**COUNTY OF WESTCHESTER  
NEW YORK**

**ADDENDUM NO. 5**

**CONTRACT NO. 20-517**

**REHABILITATION OF GLEN ISLAND APPROACH BRIDGE  
OVER NEW ROCHELLE HARBOR (BIN 3348880)  
NEW ROCHELLE, NEW YORK**

**DEMOLITION PLAN - BRIDGE**

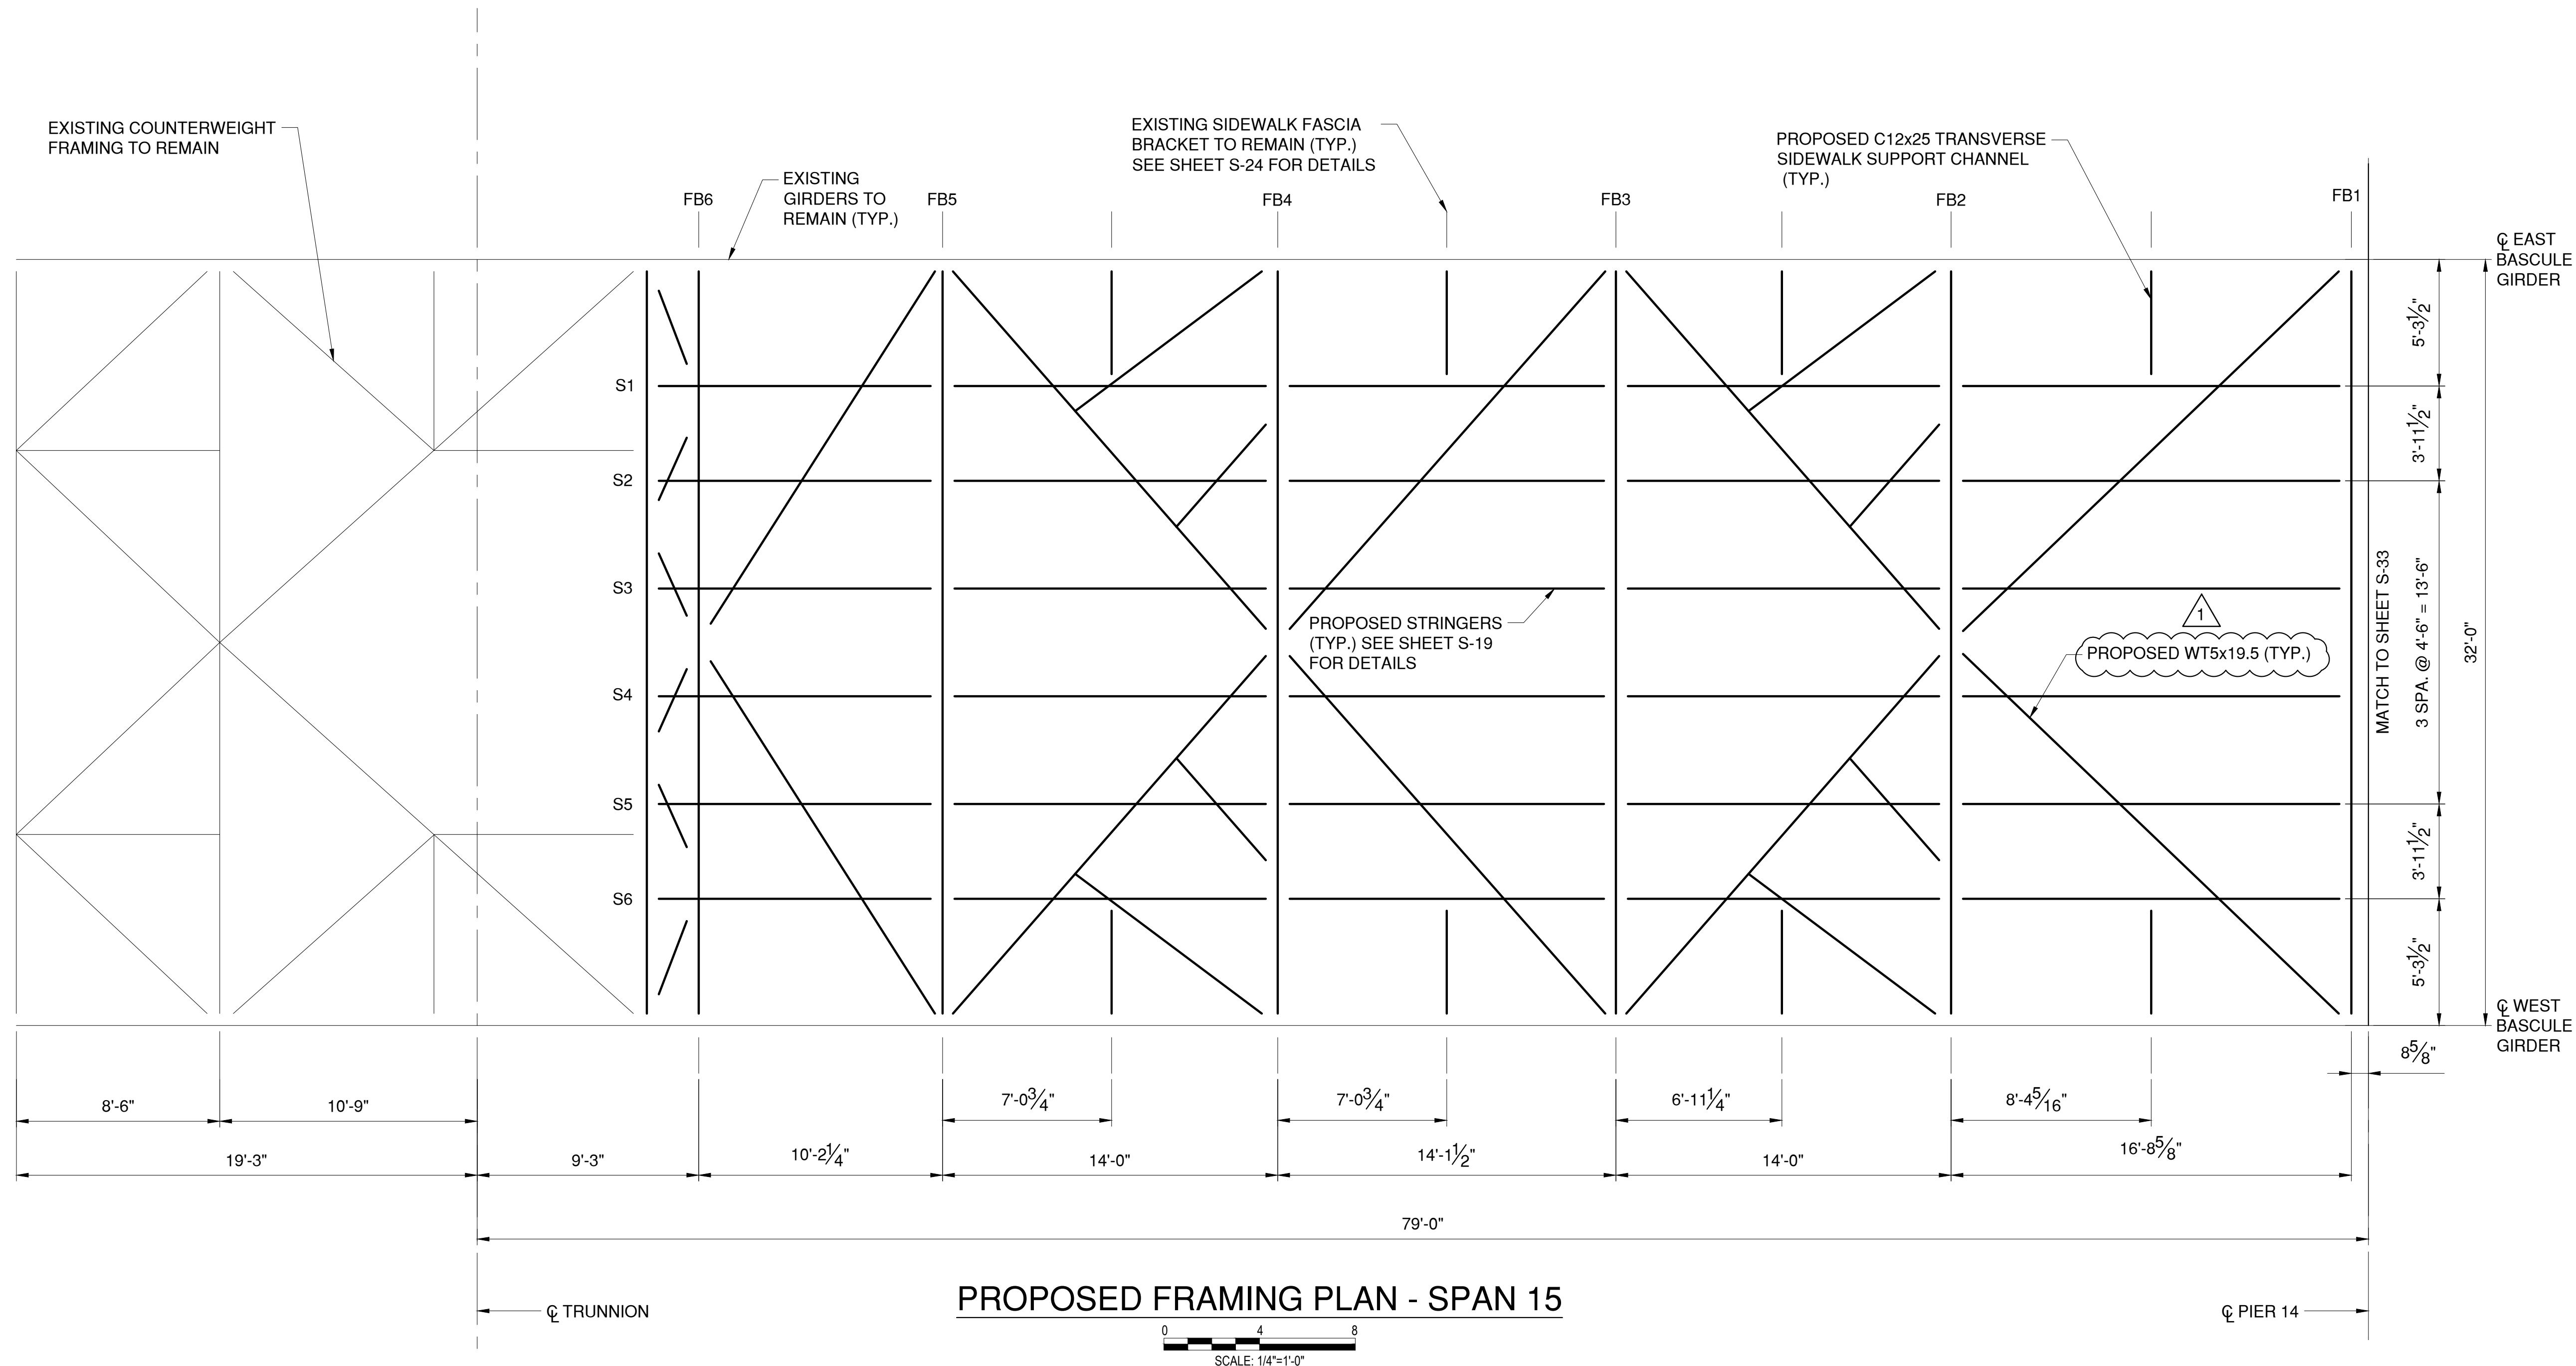
1	4/12/24	NH	DD	SIDEWALK DEMO FOR SEWER
2	4/24/24	NH	DD	OVERLAY DEMO CLARIFIED
REVISION NUMBER	DATE	MADE BY	APP'D BY	REVISION

Question #	RFI #	Contractor	Question	Response
125	011	RCC	Sheet # 43 shows "Existing Concrete Approach Overlay to be removed and paid under item 581.01". However, the approach slab appears to be a concrete surface (Not asphalt) and we need clarification as to the required scope in this area. Please advise.	Removal of the asphalt overlay on the plaza (south approach) and north approach is to be paid for under 581.01. Removal of the concrete overlay on the deck-over-counterweight is to paid for under item 581.02. Please note the deck-over-counterweight is not a traditional approach slab; it is a single span composed of stringers and a filled grid deck. See sheet number S-83 for limits of removal on deck-over-counterweight.
126	011	RCC	Please identify or provide clarification on the contract drawings of the limits of item 202.2202 vs 202.2302 (composite vs Non-composite slab sections). Otherwise, would you consider converting these two bid items into one lump sum biditems for the same scope?	The available as-builts do not indicate that shear connectors are present. In the event that shear connectors are encountered during demolition and for the purpose of quantity calculations, 10% of the existing superstructure slab was assumed to be composite and the remaining 90% non-composite. No changes to the bid items will be made.

CONTRACT NUMBER 20-517	SHEET NUMBER S-07
SHEET NO. 48 OF 212	
SCALE: AS SHOWN DATE: 03/08/2024	
DPW FILE NO. 5-04-S-483-0	REV NO. 1

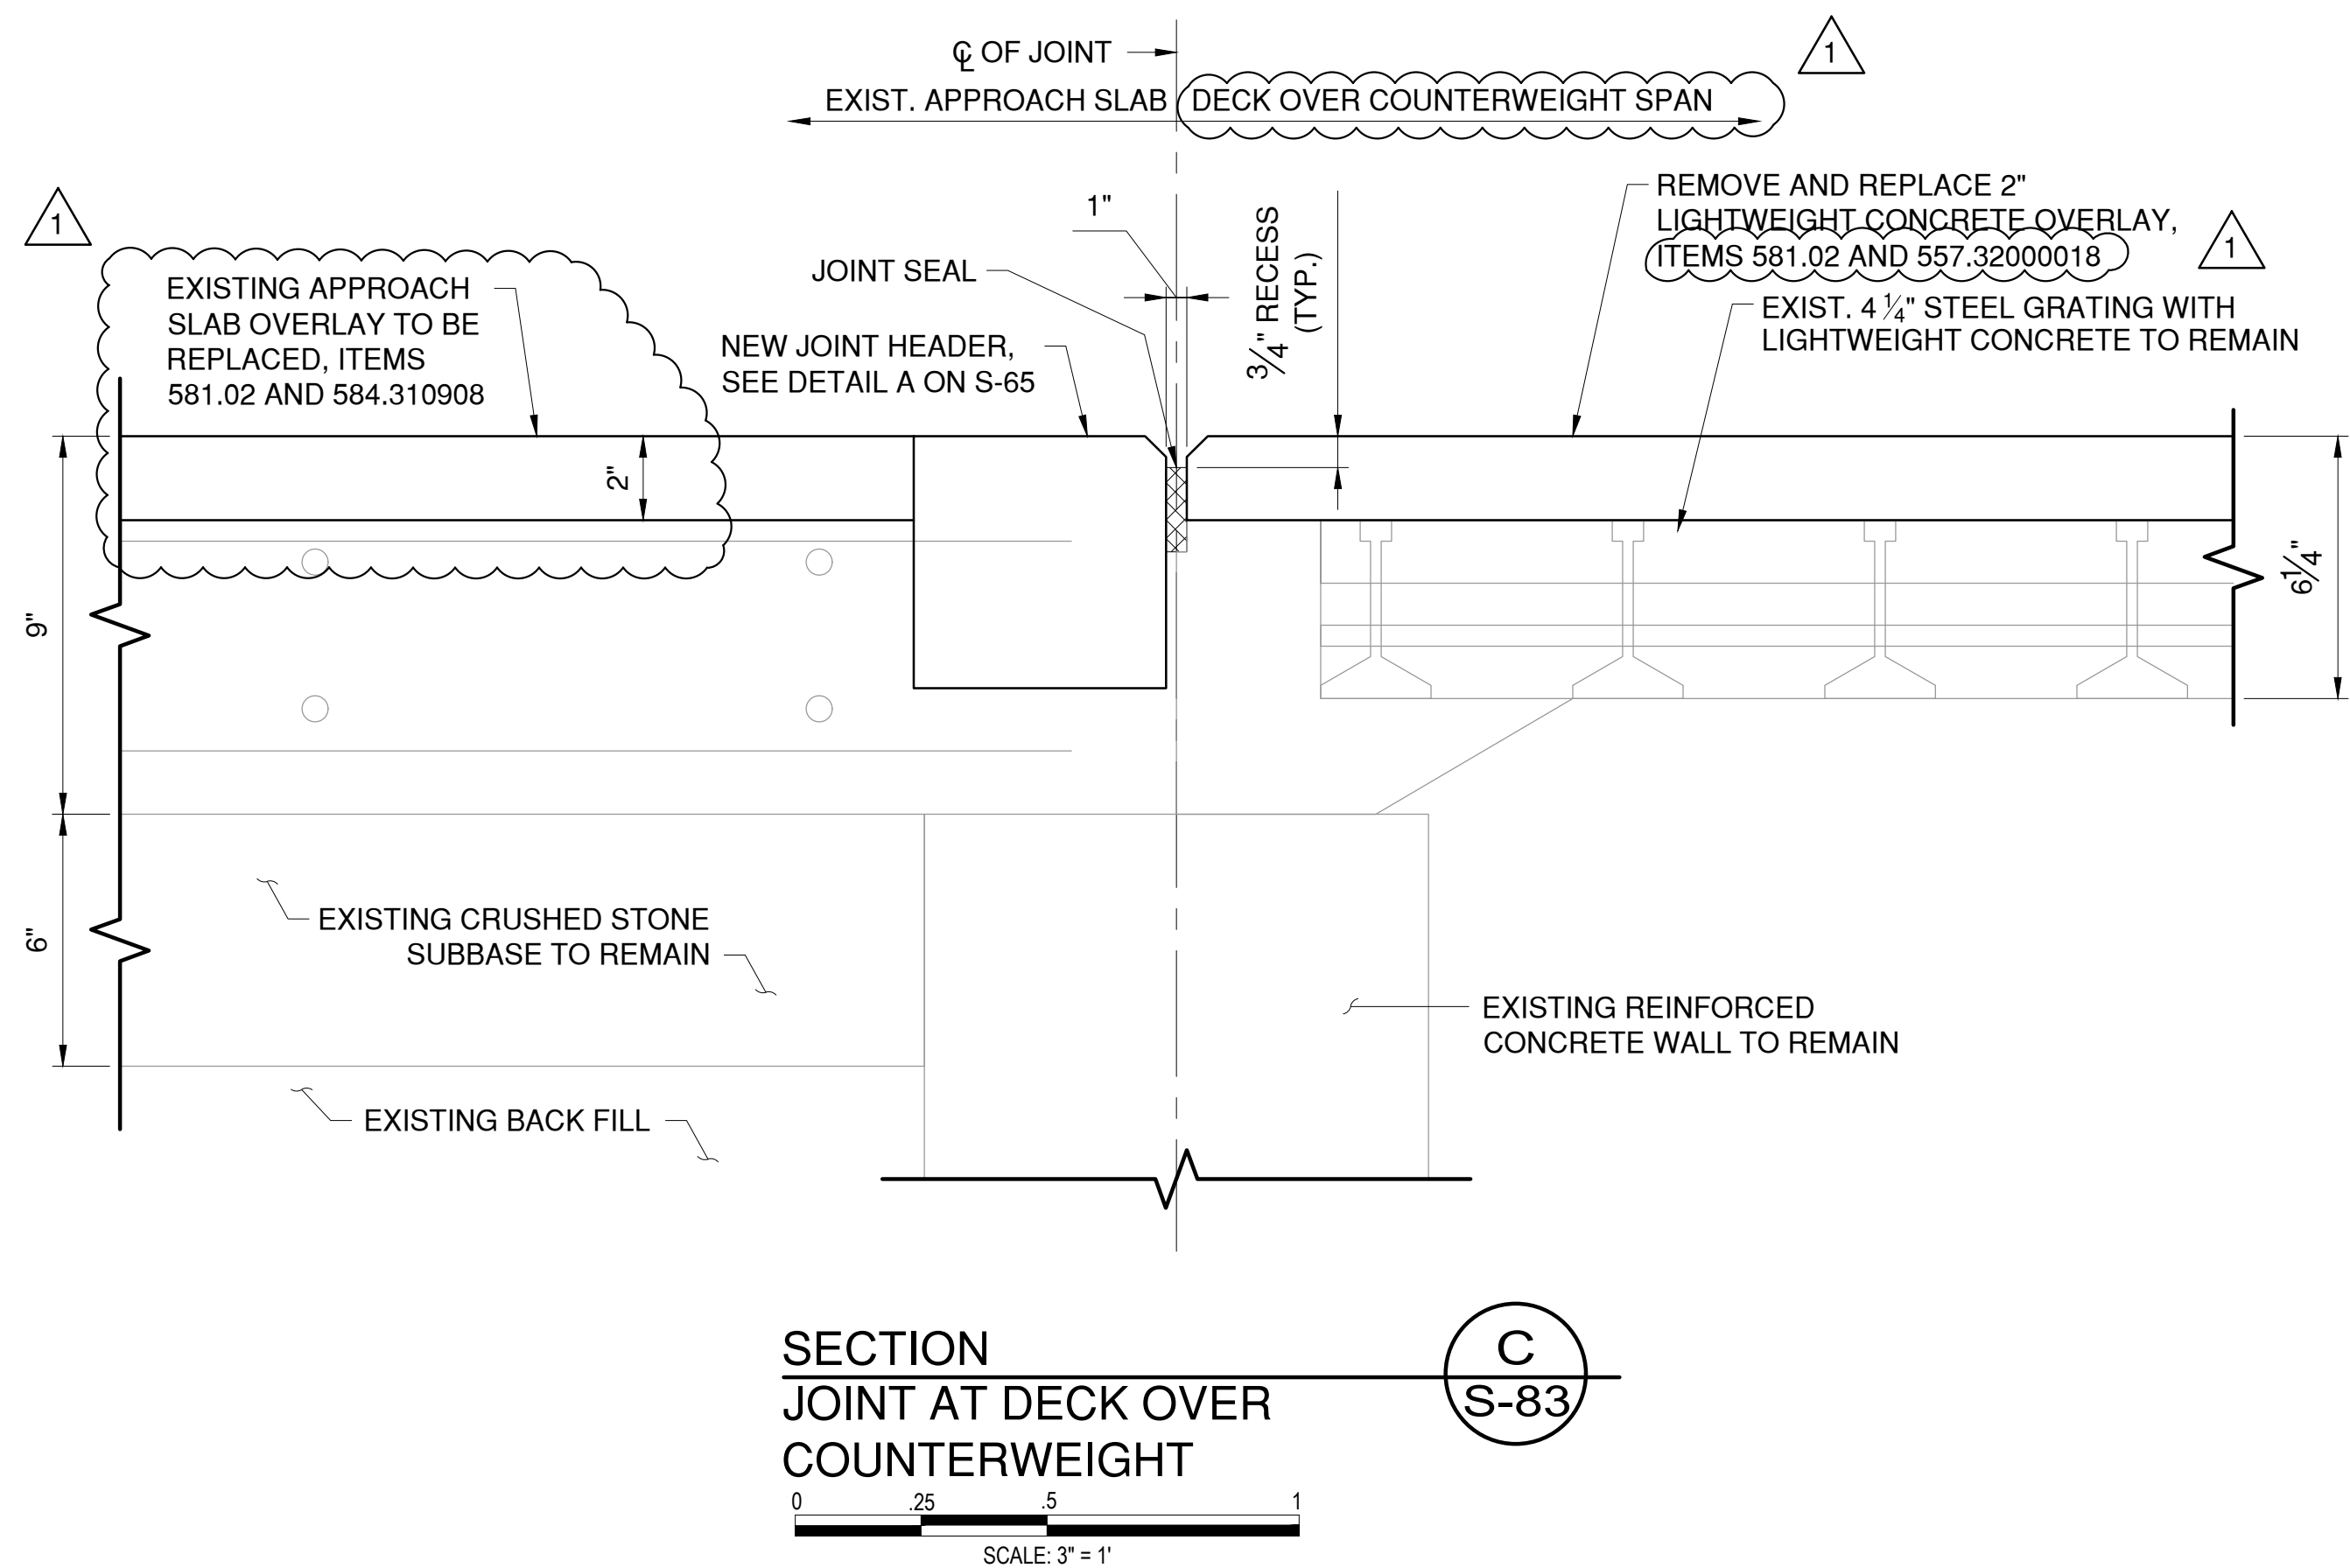
1	4/24/24	NMH	DD	LATERAL BRACING SECTION	RECORD DRAWING CERTIFICATION		WESTCHESTER COUNTY, NEW YORK DEPARTMENT OF PUBLIC WORKS AND TRANSPORTATION DIVISION OF ENGINEERING		CONTRACT NUMBER 20-517	SHEET NUMBER S-09
					<input type="checkbox"/> AS BUILT – CHANGES AS NOTED <input type="checkbox"/> AS BUILT – NO CHANGES				SHEET NO. 50 OF 212	
					CONTRACTOR		PROJECT COORDINATOR		Rehabilitation of Glen Island Approach Bridge over New Rochelle Harbor, City of New Rochelle	
					NAME _____ SIGNATURE _____ TITLE _____ DATE _____		NAME _____ SIGNATURE _____ TITLE _____ DATE _____		SCALE: AS SHOWN DATE: 03/08/2024 DPW FILE NO. _____	
REVISION NUMBER	DATE	MADE BY	APP'D BY	REVISION			STRUCTURAL		BASCULE SPAN PROPOSED FRAMING PLAN 5-04-S-485-0

139	015	American Bridge	The Plan view of the Abutment Fender shown on Sheet S-07 calls out a walkway that is "not shown for clarity". Please identify where details of this platform can be found.	See revised S-07 included with Addendum #5.
140	015	American Bridge	The Fender System Notes on Sheet G-07 call out for an FRP Handrail. Please provide location and details.	FRP handrail not required. See revised G-07 included with Addendum #5.
141	015	American Bridge	Regarding pay item description 599.061206 WE, Permanent Bridge Operation and Maintenance. Method of Measurement section 4.0 states the work will be measured per unit "month" of operation and maintenance, which shall include all materials, equipment, and labor necessary to complete the work as identified on the plans and as noted herein. There will be periods of time that the bridge will not open for boats or "operating" the bridge but is still being maintained per the requirements in the specification. Please confirm the contractor will be compensated at the Unit price per month for maintaining but not actually operating the bridge during those periods of time regardless of opening/operating the bridge.	Confirmed. Unit bid price should reflect both periods of time that the bridge is opening regularly and time that it is not but will still need to be maintained per the specifications.

CONTROL HOUSE SCHEDULES

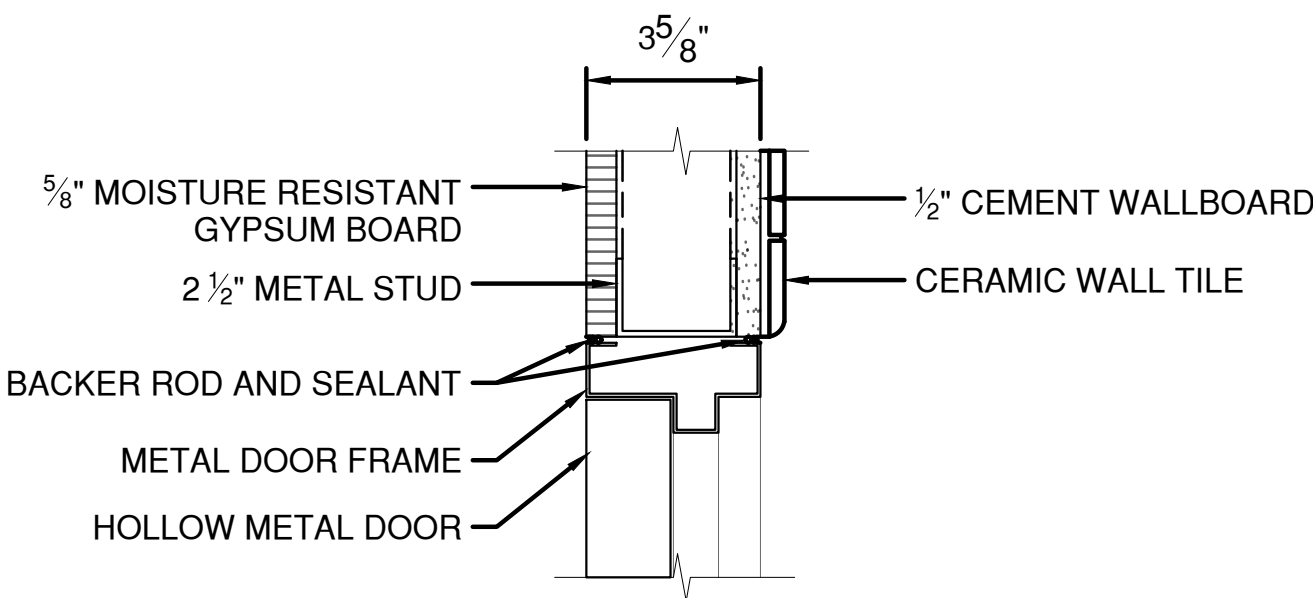
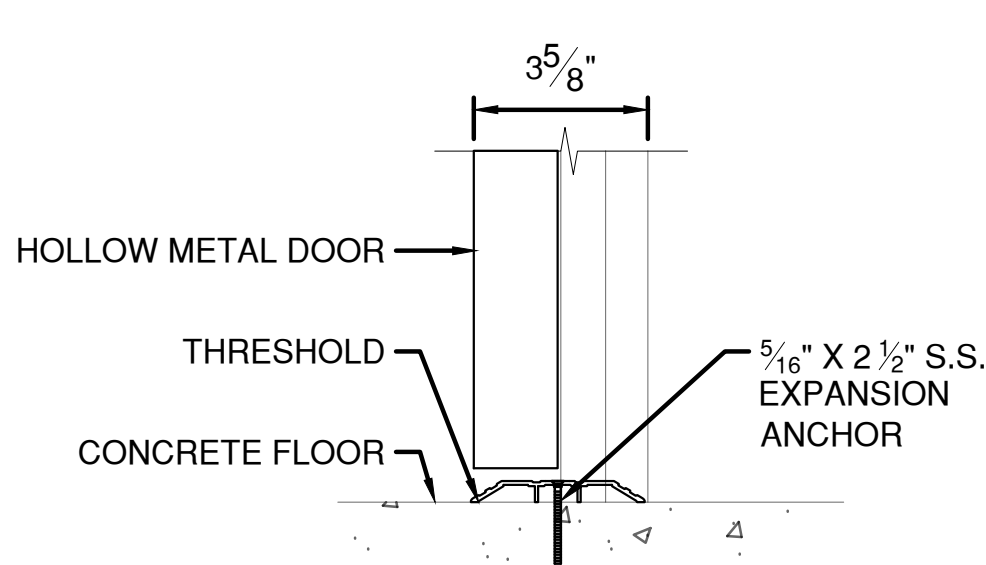
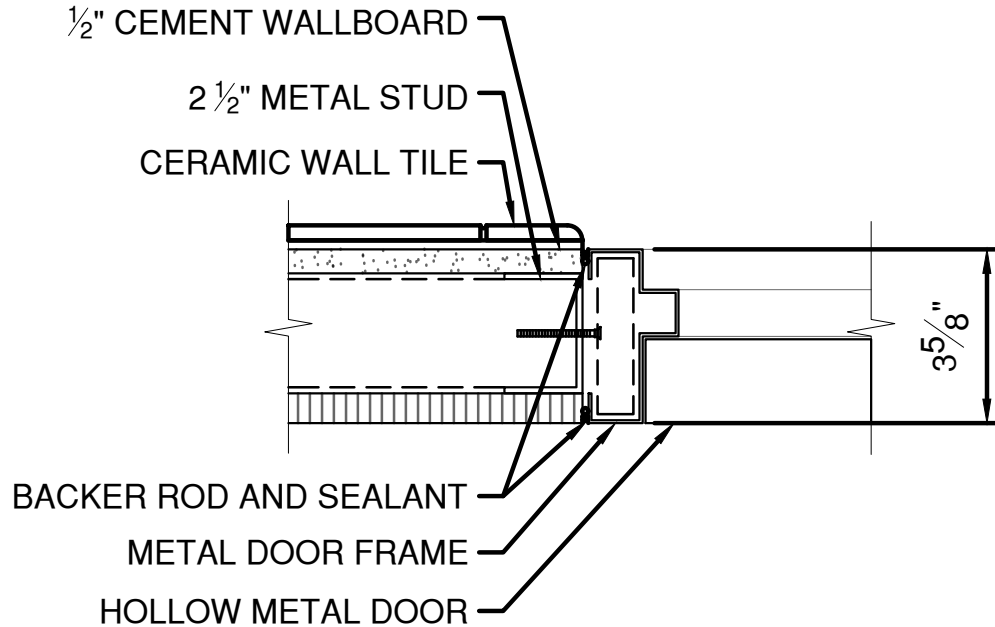
1	4/24/24	EB	DT	SCHEDULE NOTE ADDED
REVISION NUMBER	DATE	MADE BY	APP'D BY	REVISION

135	012	RCC	Drawing A-10 calls out (4) Fire Alarm Devices no mention of Central Station Monitoring. Drawing E-12 Note 11 discusses a Fire Alarm 'SYSTEM" , please provide a Specification so that we may ascertain what is required.	Fire alarm system consists of 4 standalone (not centrally monitored or controlled by a Fire Alarm Control Panel (FACP)) hardwired and interconnected combination carbon monoxide/smoke detectors. The intent of the fire alarm system is to notify the occupants of the control house that a smoke or carbon monoxide event has been triggered. The occupants of the Control house will then call supervisors and/or first responders as required. A note will be added to drawing A-10 to clarify this.

1. FIRE ALARM SYSTEM CONSISTS OF 4 STANDALONE (NOT CENTRALLY MONITORED OR CONTROLLED BY A FIRE ALARM CONTROL PANEL (FACP)) HARDWIRED AND INTERCONNECTED COMBINATION CARBON MONOXIDE/SMOKE DETECTORS. THE INTENT OF THE FIRE ALARM SYSTEM IS TO NOTIFY THE OCCUPANTS OF THE CONTROL HOUSE THAT A SMOKE OR CARBON MONOXIDE EVENT HAS BEEN TRIGGERED. THE OCCUPANTS OF THE CONTROL HOUSE WILL THEN CALL SUPERVISORS AND/OR FIRST RESPONDERS AS REQUIRED.
